**Mark B. Bezilla**  
Site Vice President724-682-5234  
Fax: 724-643-8069April 2, 2003  
L-03-057U. S. Nuclear Regulatory Commission  
Attention: Document Control Desk  
Washington, DC 20555-0001**Subject: Beaver Valley Power Station, Unit No. 1  
BV-1 Docket No. 50-334, License No. DPR-66  
Reply to Request for Additional Information Regarding  
Order EA-03-009 Relaxation Request**

**Responses to NRC Questions  
Regarding Beaver Valley Power Station (BVPS) Unit 1  
Order EA-03-009 Relaxation Request**

**Figure 7**  
**Hoop Stress Vs Distance from Bottom of Weld**  
**40.0° CRDM Penetration Nozzle -Uphill**

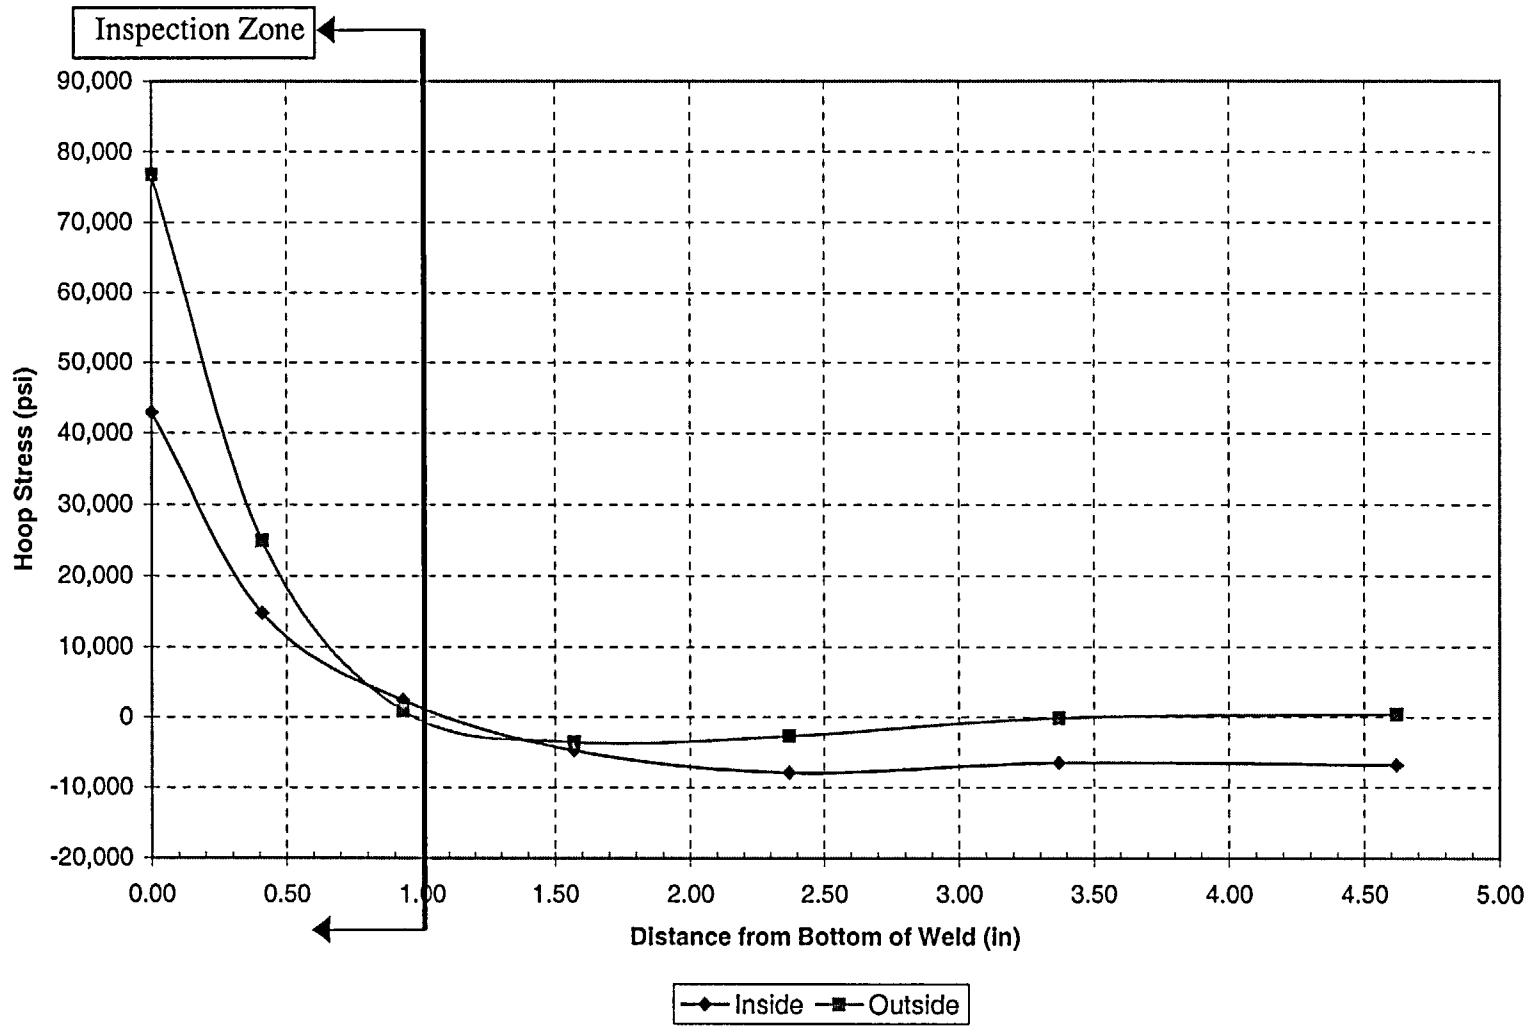
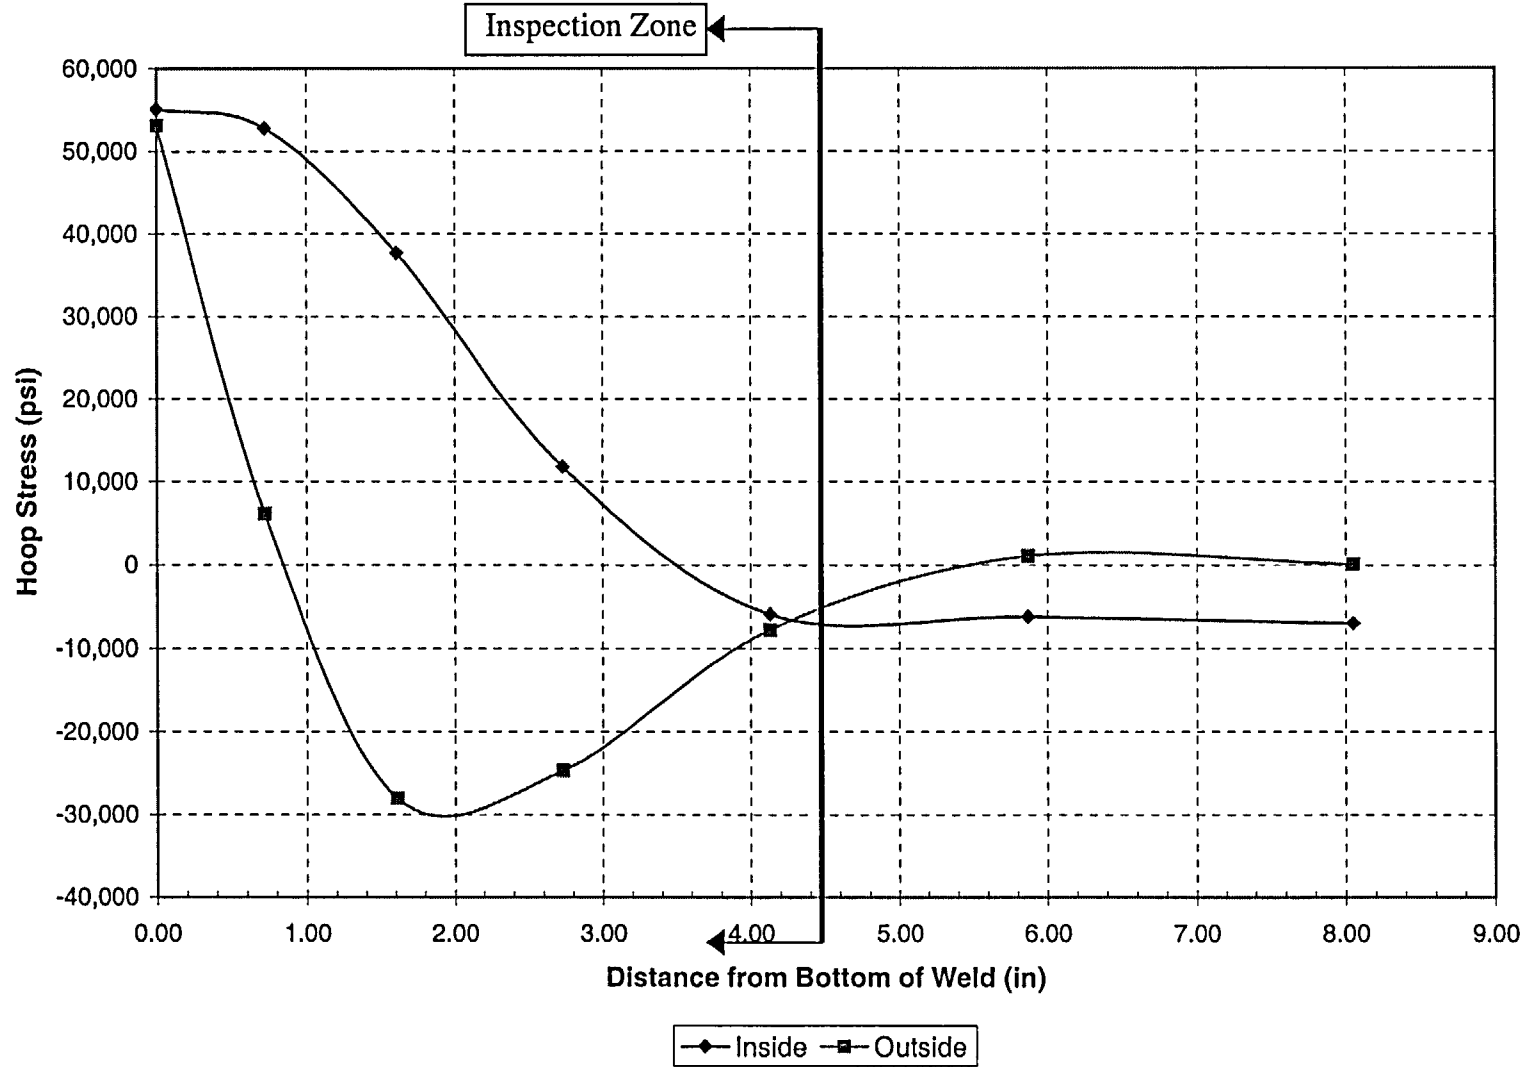
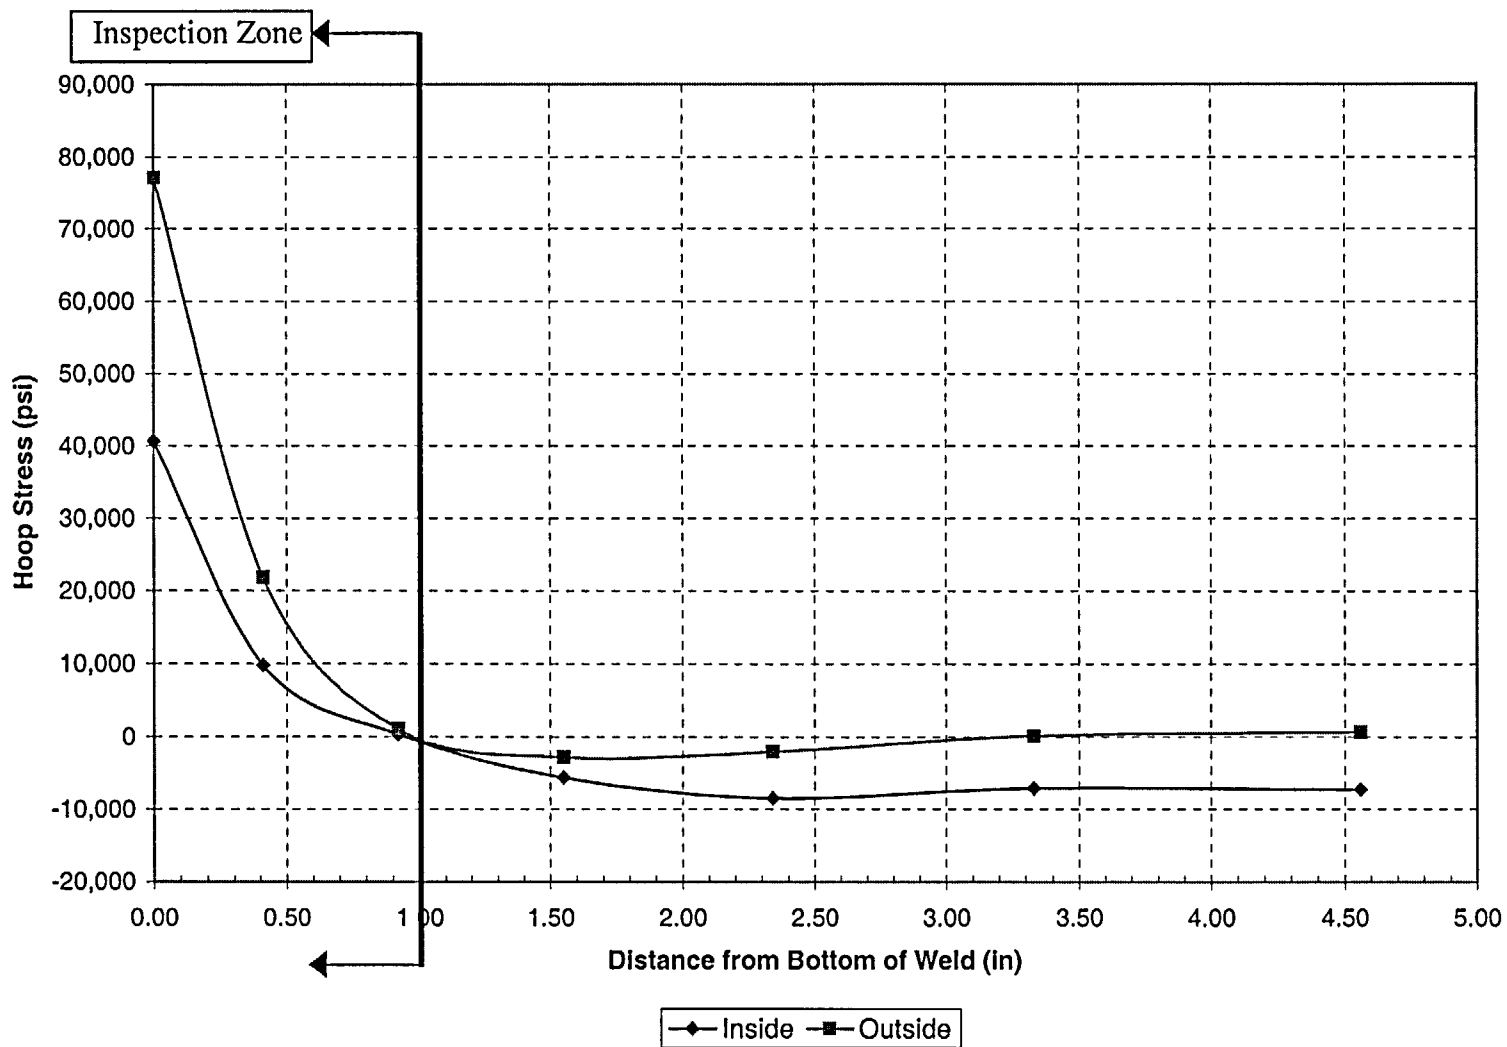
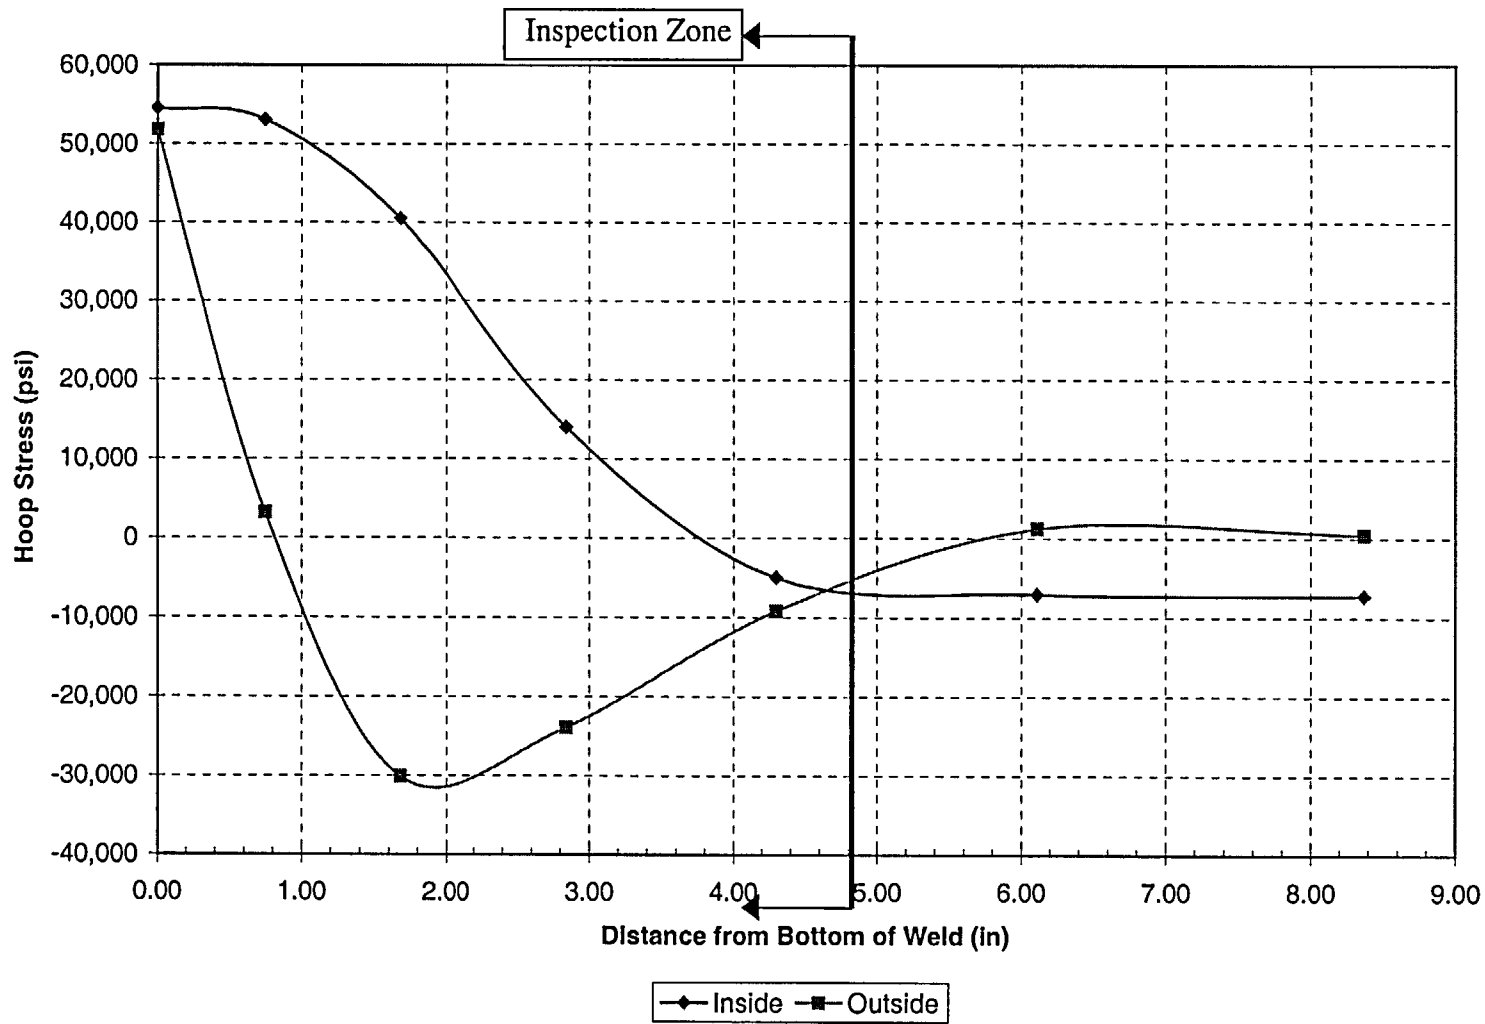
**Question 2.** *The request states that, "The magnitude of the stresses in these portions of the nozzles is low based on information from other plants of similar design and construction." Discuss how this information is applicable to your plant. Provide tabular listings of the maximum stress in the cross-section from the top of the J-groove weld region to the area covered by your relaxation request.*

The hoop stress distributions as a function of distance from the bottom of the weld for a range of penetration nozzles located at the center of the vessel head to the outermost nozzles are provided in Figures 1 to 9. The expected "inspection zone" is also identified in each figure. This information is provided in graphical versus tabular format. As shown in Figures 1 to 9, the magnitude of the stresses in the unexamined portion of the nozzles is low. See response to Question 3 for further information.

**Figure 10**  
**Through-Wall Axial Flaws Located in the 28.6 Degree Row of**  
**Penetrations, Uphill Side - Crack Growth Predictions**

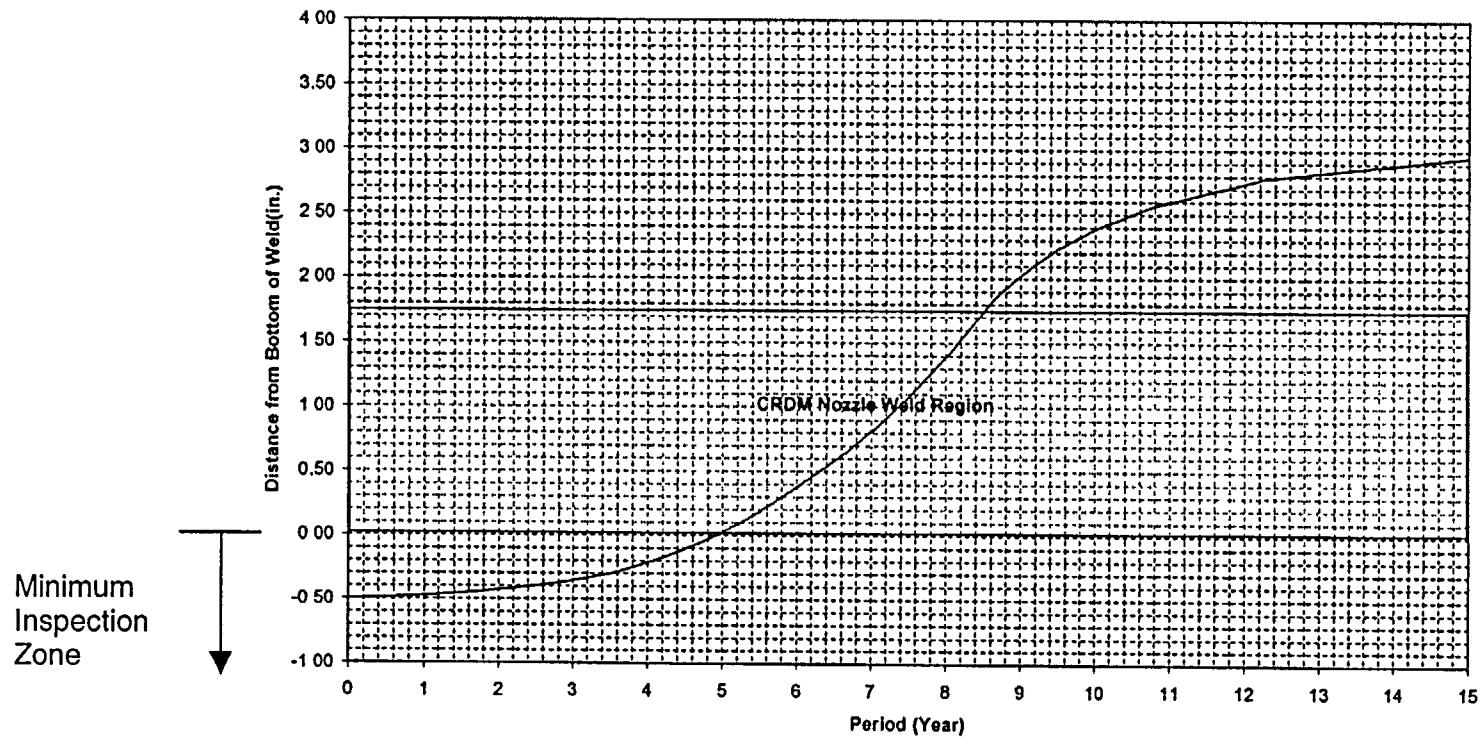
**Question 3. The request also states that, "there are no concerns with the structural integrity of the vessel head penetration nozzles from the unexamined bottom portions of the nozzles addressed in this request." Provide the technical basis, such as an analysis or an evaluation to show that cracks initiated from the unexamined area will not propagate into the pressure boundary and exceed the Code allowable crack sizes within one operating cycle, based on a conservative crack growth rate from the industry operating experience.**

The examination coverage from the bottom of the J-groove weld towards the bottom of the nozzle is expected to be a minimum of 1.0 inch. To determine the significance of such an axial flaw located more than 1.0 inch below the weld, a flaw tolerance approach is used. The flaw evaluation results obtained from a plant of similar design and construction as BVPS Unit 1 were used. See response to Question 2. The evaluation postulated an axial flaw in the unexamined area below the weld. The evaluations performed are based on a methodology consistent with the recently approved Section XI flaw evaluation approach, with a Primary Water Stress Corrosion Cracking (PWSCC) crack growth rate that is consistent with the MRP-55 Rev. 1 report. A through wall axial flaw was postulated in the nozzle material growing upwards towards the bottom of the weld. Since the stresses for the portion of the nozzle more than 1.0" below the weld are too low to propagate an axial flaw, the flaw evaluations start at 0.5" below the weld and the time to propagate the flaw in the nozzle to the bottom of the weld (start of the pressure boundary portion of the nozzle material or toe of the J-groove weld) was determined. Assuming a through wall flaw below the weld, with the flaw end located at 0.5" below the weld (which is in the area of complete examination coverage), an axial flaw would take approximately 5 years of operation to grow to the point of contact with the weld, and even longer for it to grow from the bottom of the weld upwards through the pressure boundary. This time period is significantly greater than the current inspection frequency of every refueling cycle (approximately 18 months for BVPS Unit 1) identified in NRC Order EA-03-009.

Figure 10 provides a graphical presentation of the above flaw evaluation discussion for the limiting penetration location. Based on the crack growth results shown in Figure 10, there are no concerns with the structural integrity of the reactor vessel head penetration nozzles that could be caused by axial cracking in the unexamined non-pressure boundary portion of the nozzle material for a period of approximately 5 years of operation.
